Access Compliance Report

Public Rights-of-Way

(Curb Ramps)

Intersection ID: 28863	Main Street: HAMPTON_PLACE_DR	Cross Street: DELAMERE_LN	Location: W
ADA ID: 263142B8F5AB	Ramp Type: PerpDiag	Initial Pass/Fail: Fail	Overall Compliance: No
Severity Score: 12.5			
Codes/Mitigation Info/Possible Solution		Field Measurements/Component Compliance

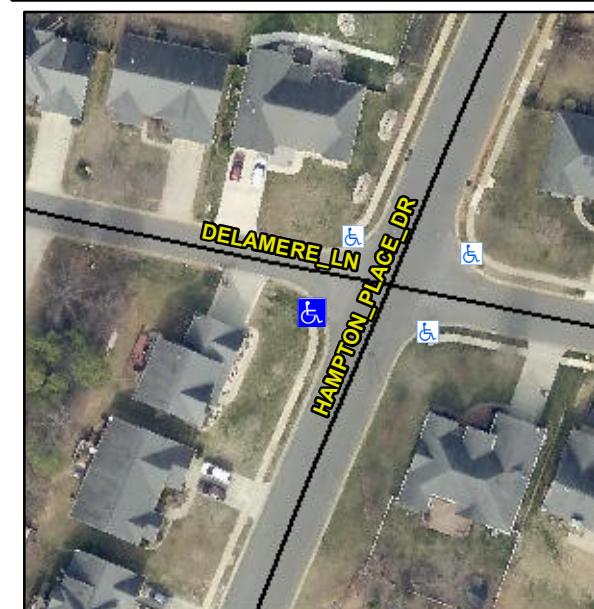
Surveyor Notes:

N/A

Not Found, R304.5.3

Possible Solutions:

Remove & Replace Curb Ramp With Two New Directional Ramps or Equivalent.
